THE GARDENS AT NORTH CAREFREE CONSTRUCTION DRAWINGS EL PASO COUNTY, STATE OF COLORADO

| GARDENS AT NORTH CAREFREE TITLE SHEET | |

**THE GARDENS AT NORTH CAREFREE
 PLAN AND PROFILE
 STORM SEWER 2 & 3**

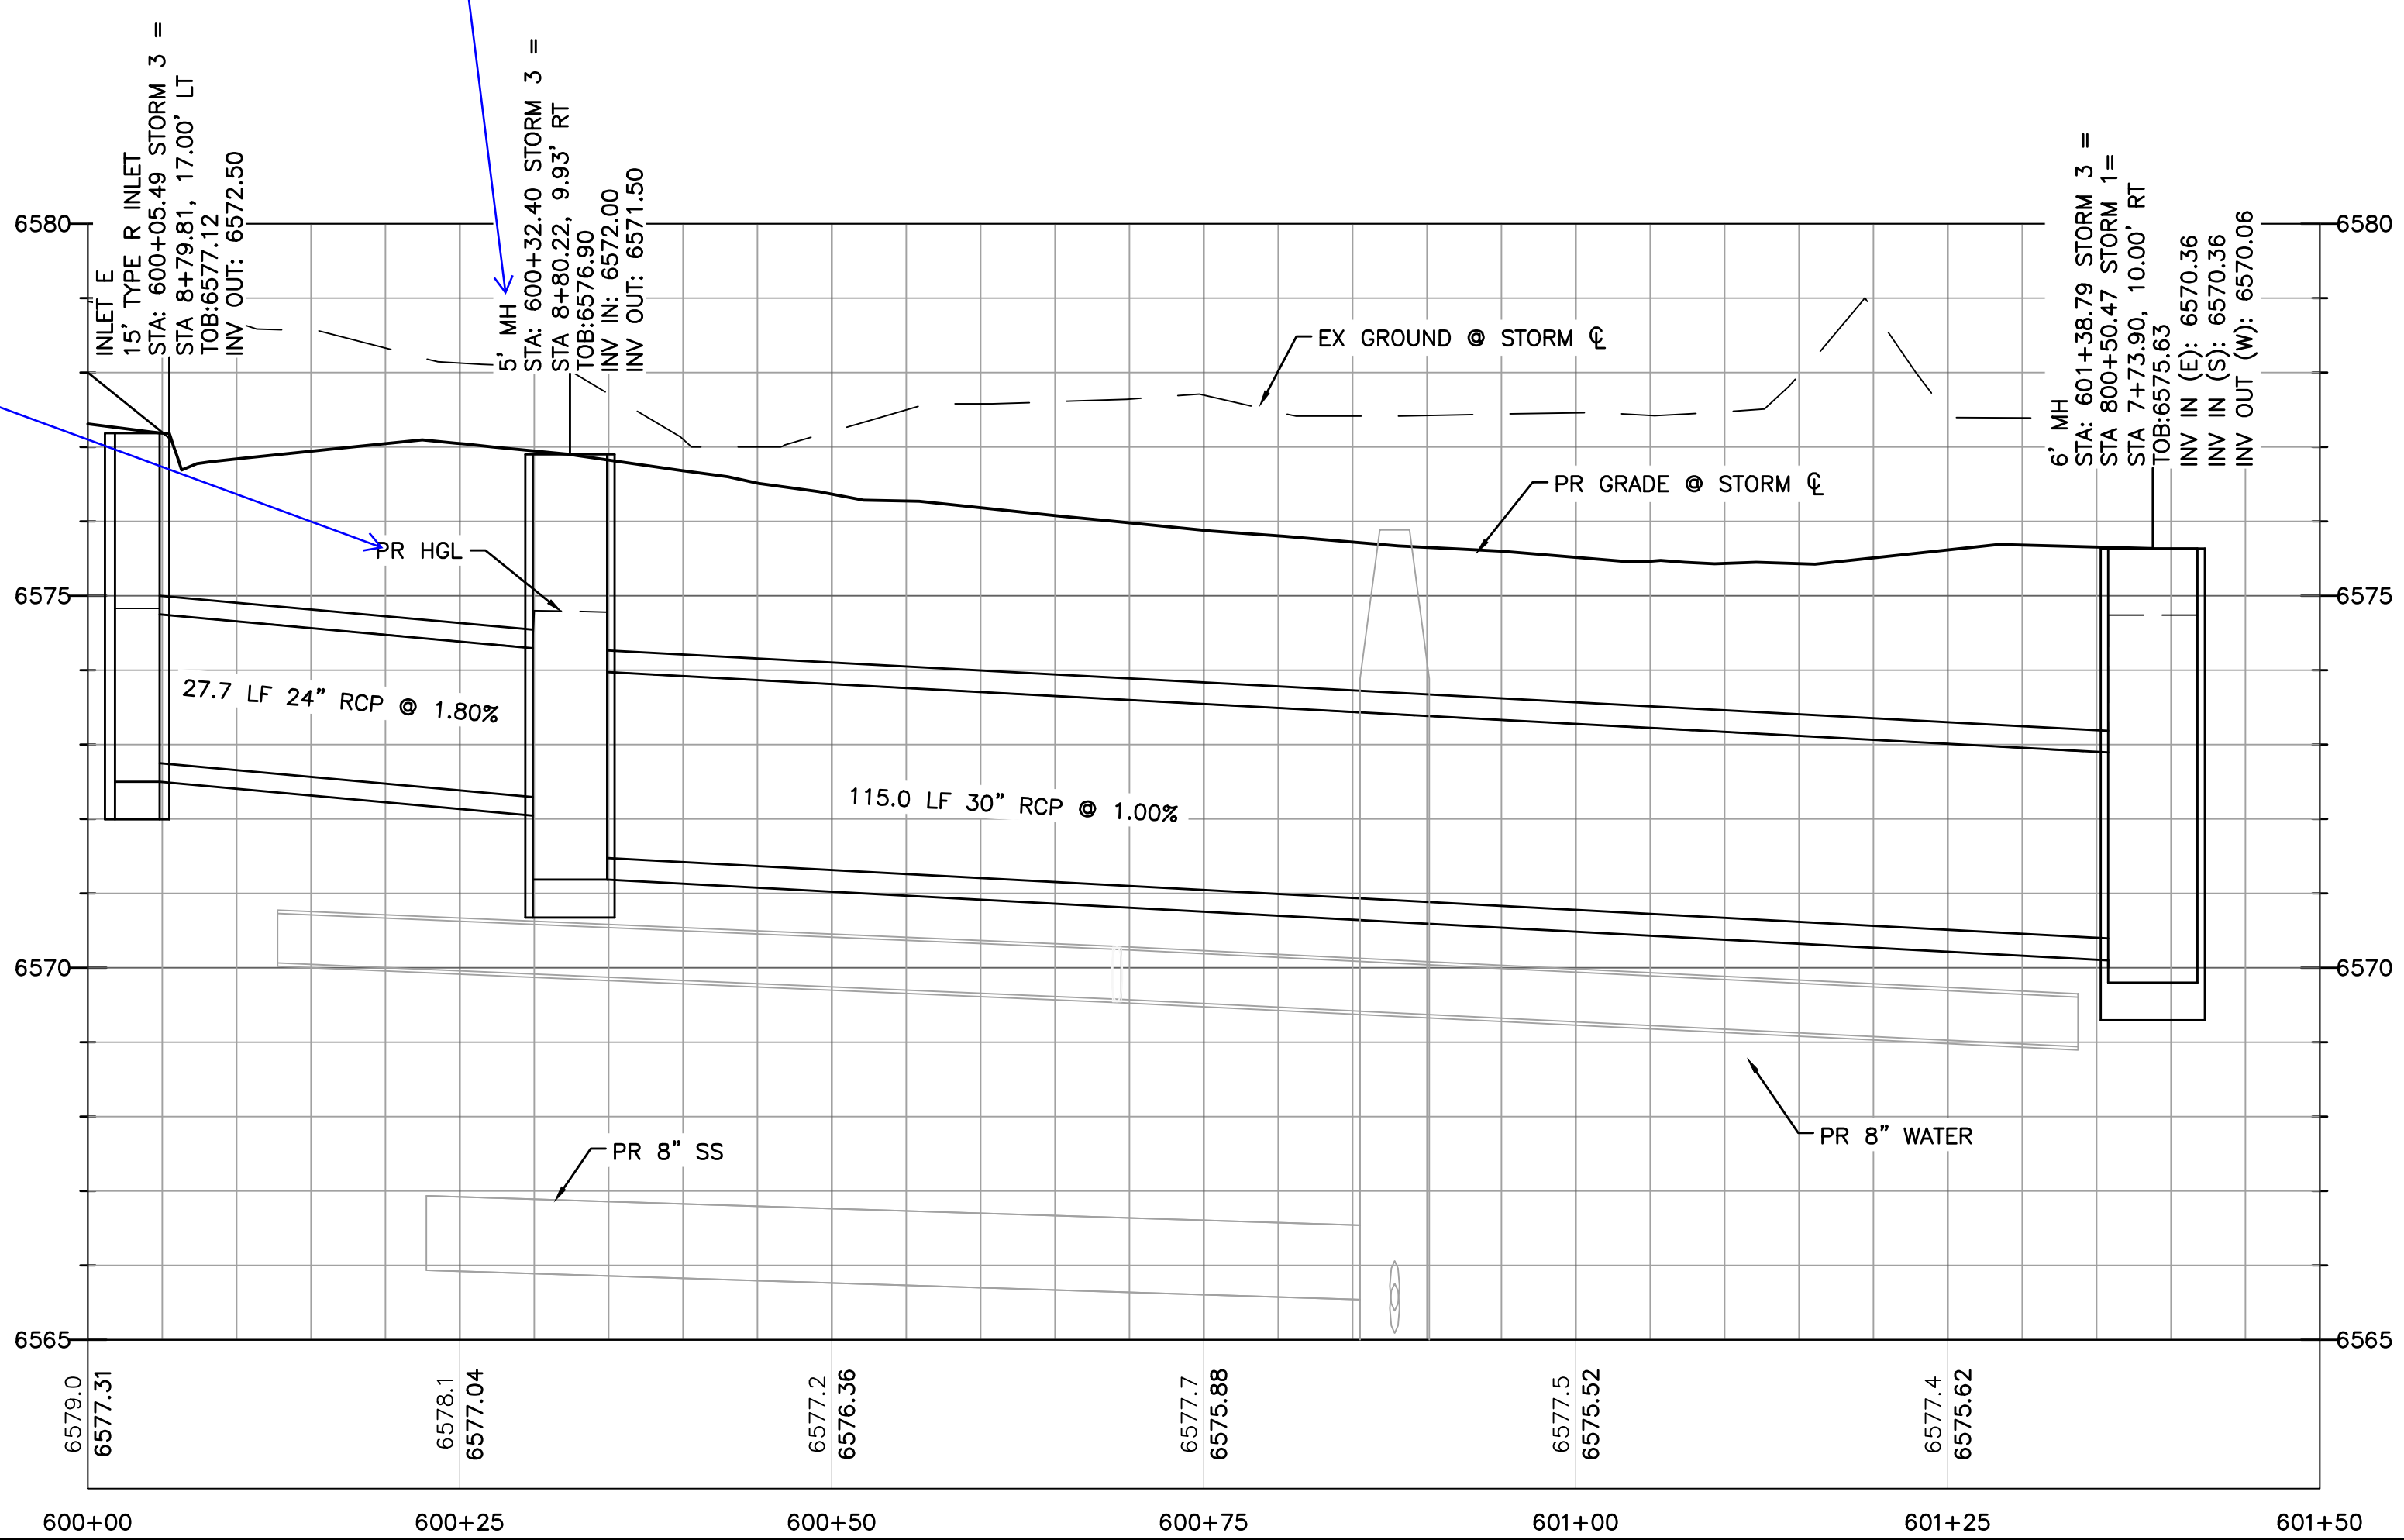
Please indicate this as 100 yr HGL

Provide EPC manhole details in the plans and indicate what type is used at each manhole.

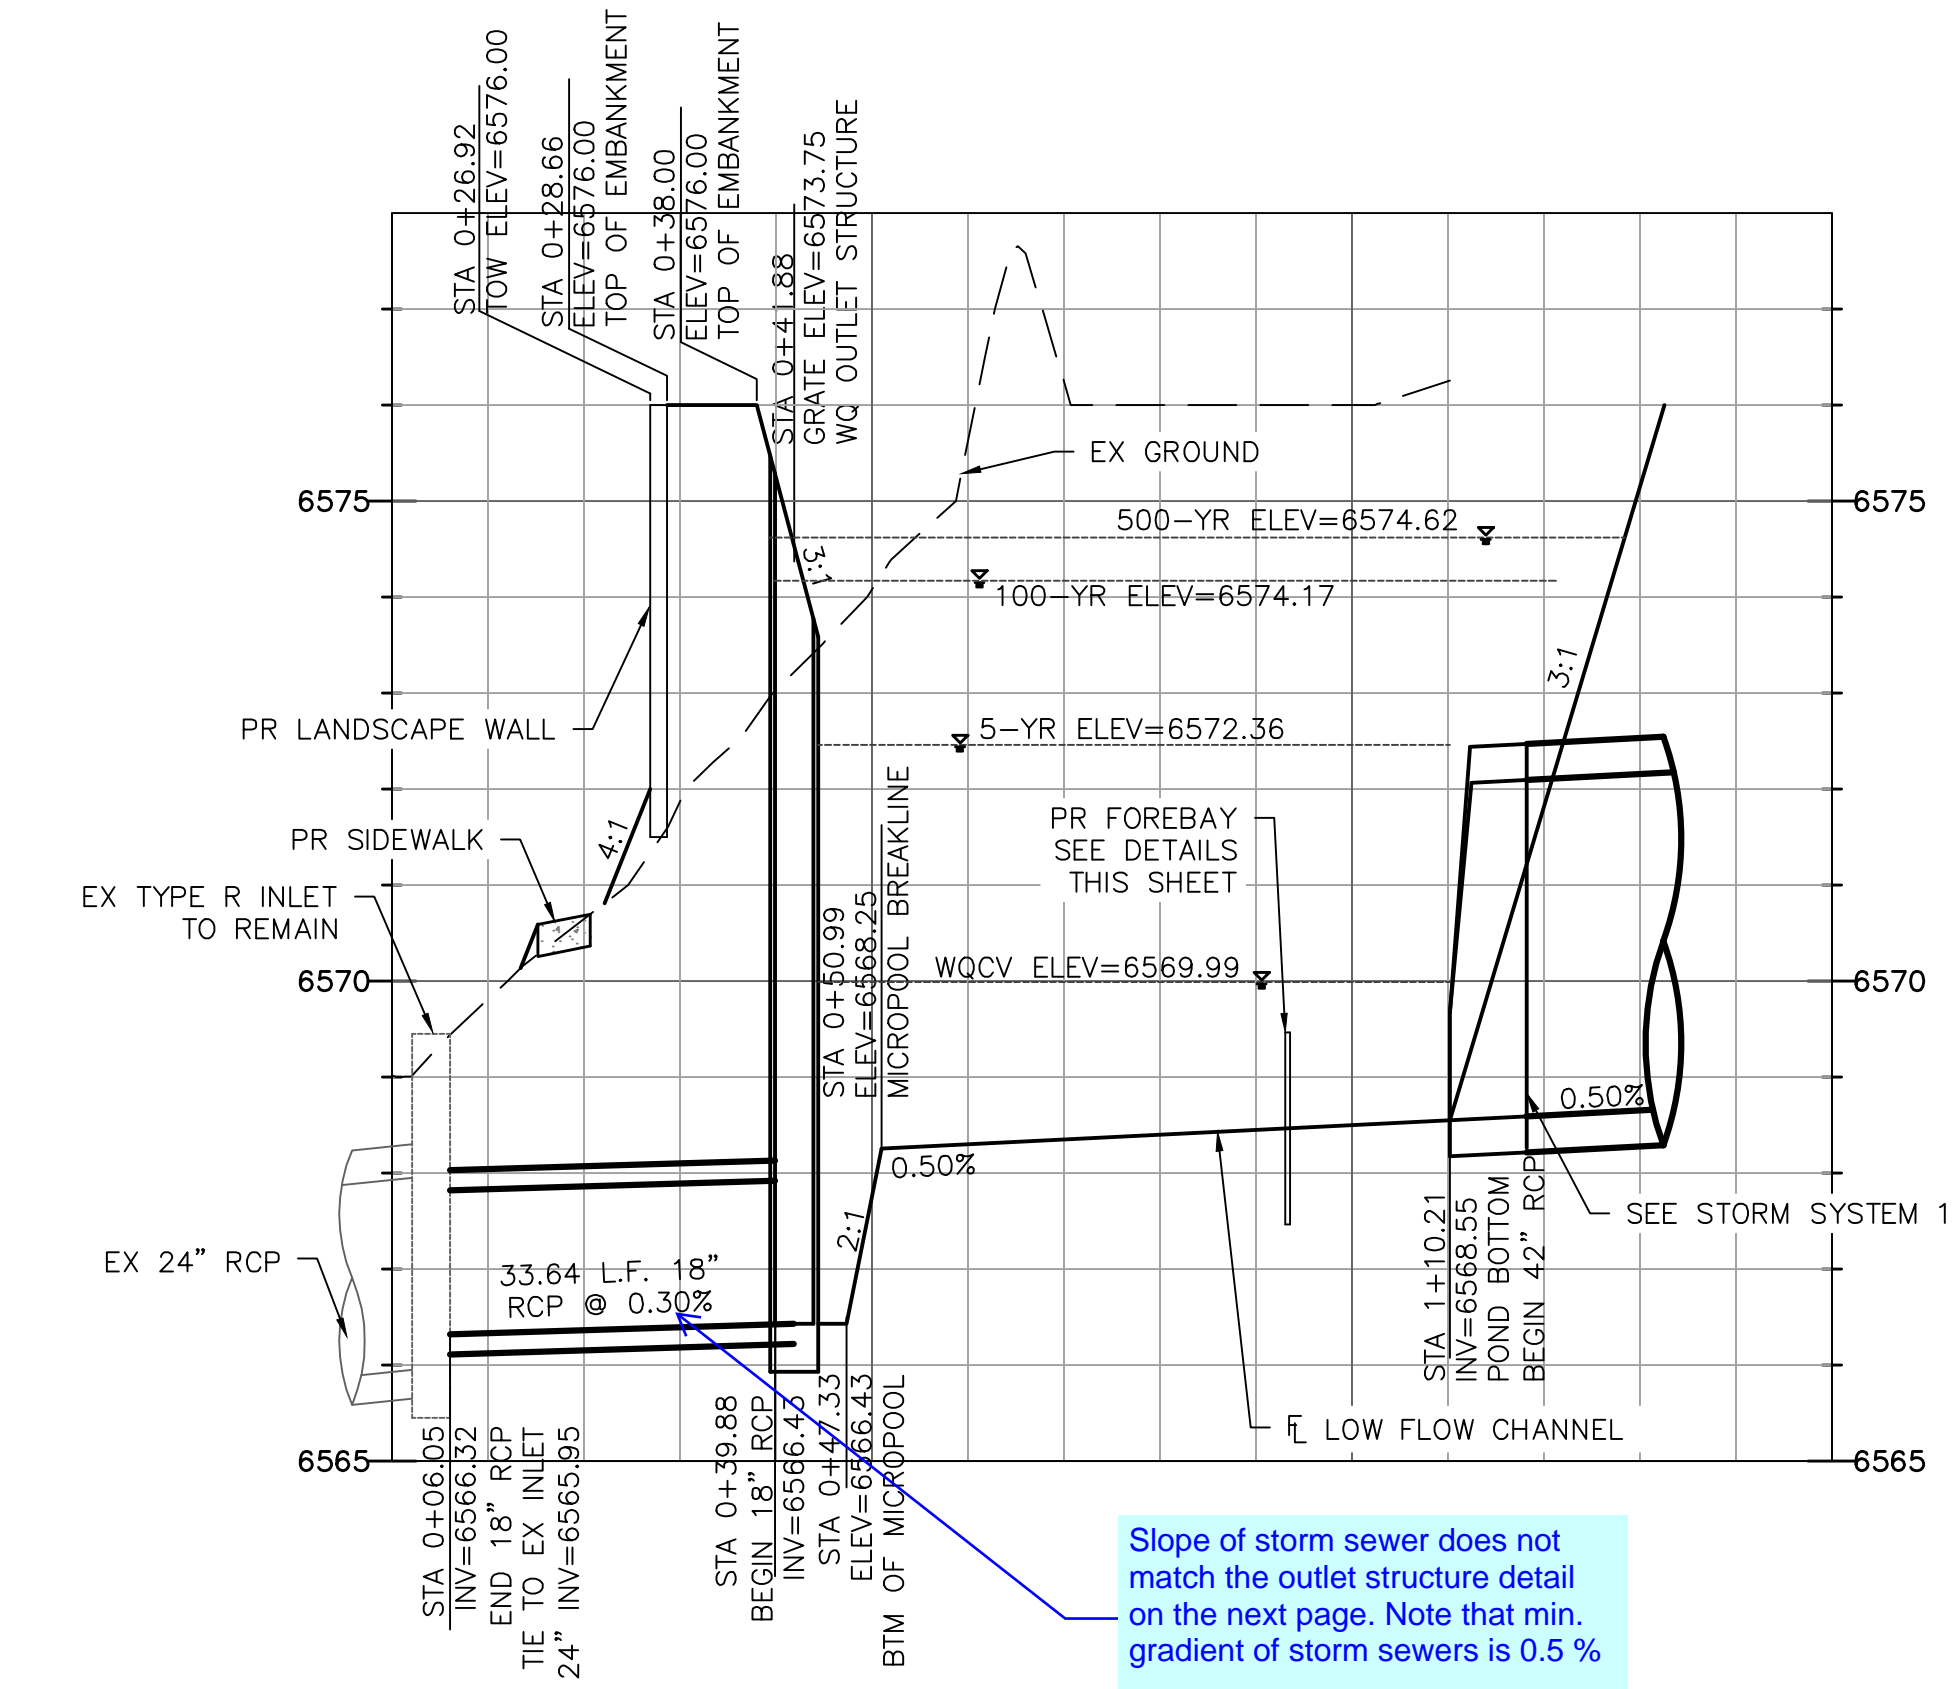
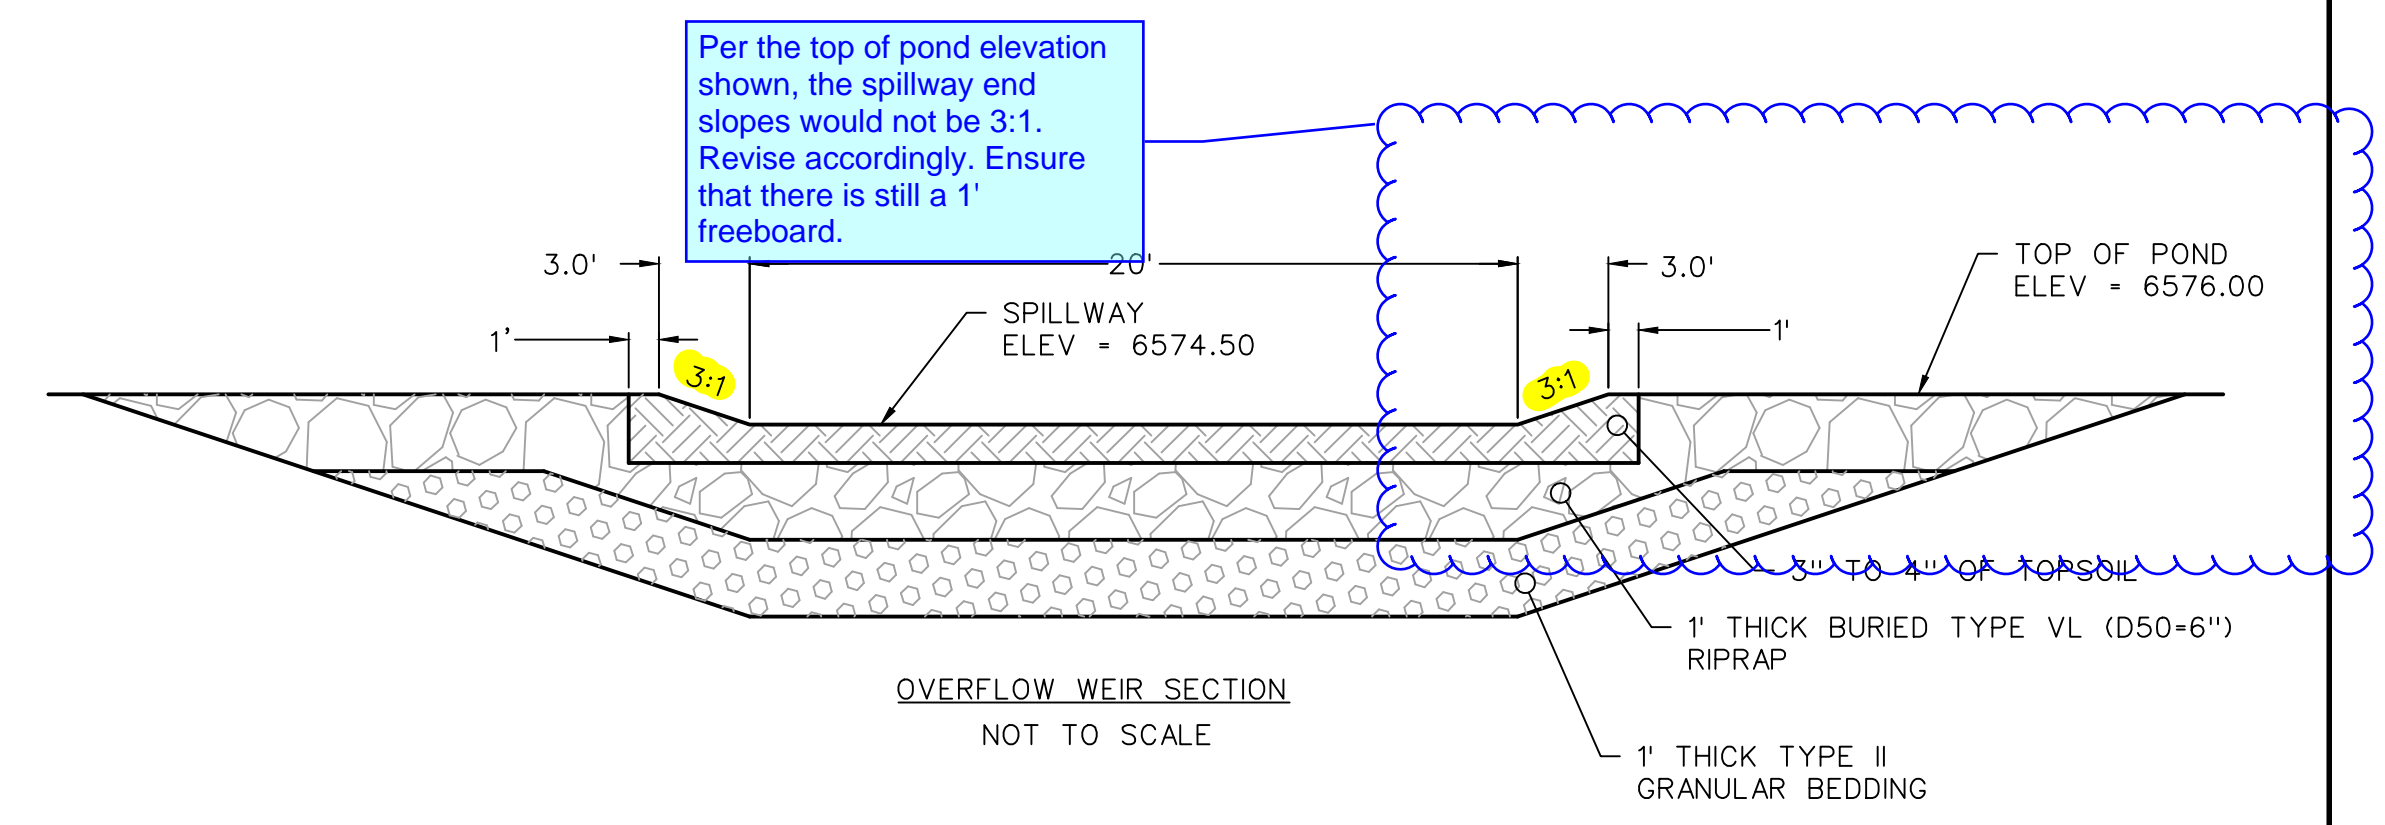
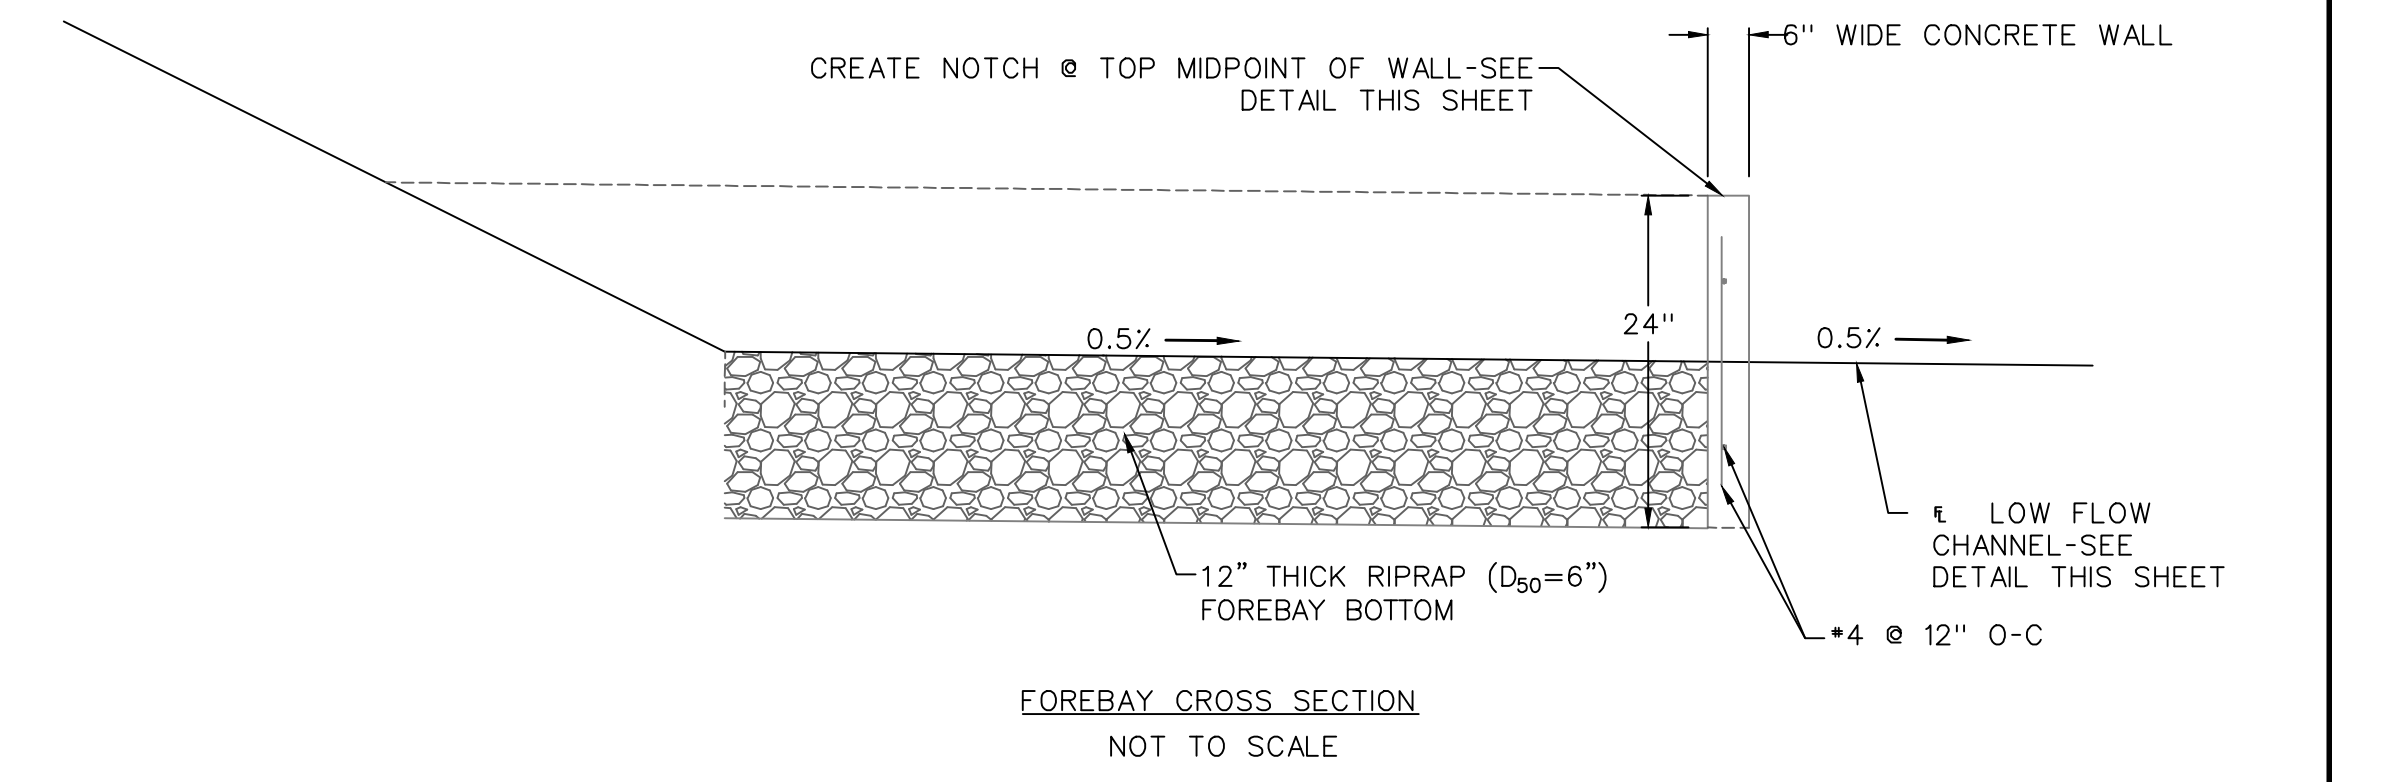
Provide access ramp to bottom of the pond per DCM Vol. 1, Section 11.2.2

Slope of storm sewer does not match the outlet structure detail on the next page. Note that min. gradient of storm sewers is 0.5 %

use concrete trickle channel

Per the top of pond elevation shown, the spillway end slopes would not be 3:1. Revise accordingly. Ensure that there is still a 1' freeboard.
